This document describes changes of the CTL-2000 Product HW revision from Rev 01.00 (PCB v1.3) to Rev 01.10 (PCB v1.7).

<b>Product Description:</b> CTL-2000 Main Board & Device	
<b>Product HW Revision:</b> Rev 01.00 to Rev 01.10	
<b>PCB Number:</b> EPCB-00156-001 Rev1.3, Rev1.4, Rev1.5, Rev1.7	
<b>PCBA Number:</b> EPCA-00125-101 rev 1.7	
<b>Instruction prepared by:</b>  Maryam Mesgari John Lopes	<b>Instruction date:</b>  5 / 10 / 2023

## Changes applied to Rev1.4 compare with Rev1.3:

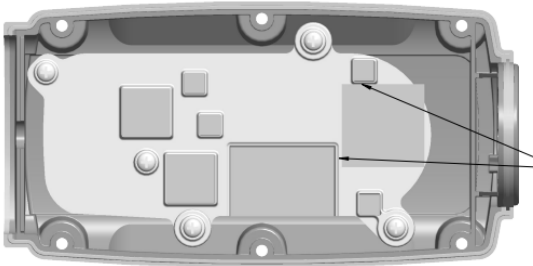
3. Plastic Isolation barrier sheet added and thermal pads updated from multiple small pads to one large pad between heatsink and PCBA.

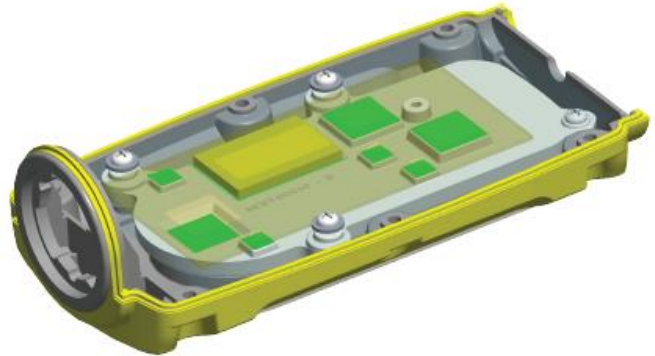
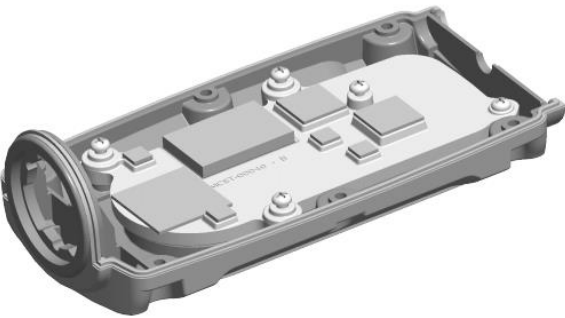
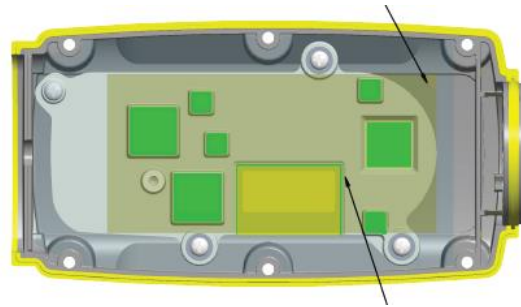
4. Housing colour update. Updated top and bottom case is yellow only.
